Process Sheet

: CU-DAR001 Dart Helicopters Services

: PLATE

Part Number Drawing Number : D32191

D3219-1 PLATE

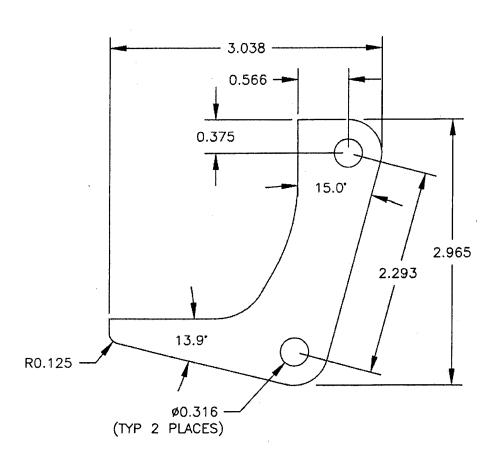
NCR: V	ALA.	WORK ORDER NON-CONFORMANCE (NCR)							
DATE	STEP	Description of NC Section A	'Initial Design Mgr				Approval Design Mgr	Approval QC Inspector	
06-07-13	4	2 parts scrap. Side damage (deep.) from at the pierce point, too close to the hole, due to W.J. Splash back.	OSEVO	Design Mgr Oles troy.	500 8007213	607.3	200	Q-0713	
		,						- 10 m

W/O:		WORK ORDER CHANGES								
DATE	STEP	PROCEDURE CHANGE By		PROCEDURE CHANGE By Date		Approval Mfg / Design Mgr				
16-07·3	6	QCS vegid. Perm. Change	SB	06/07/12	38	Basip	0.07.13			
	1-x
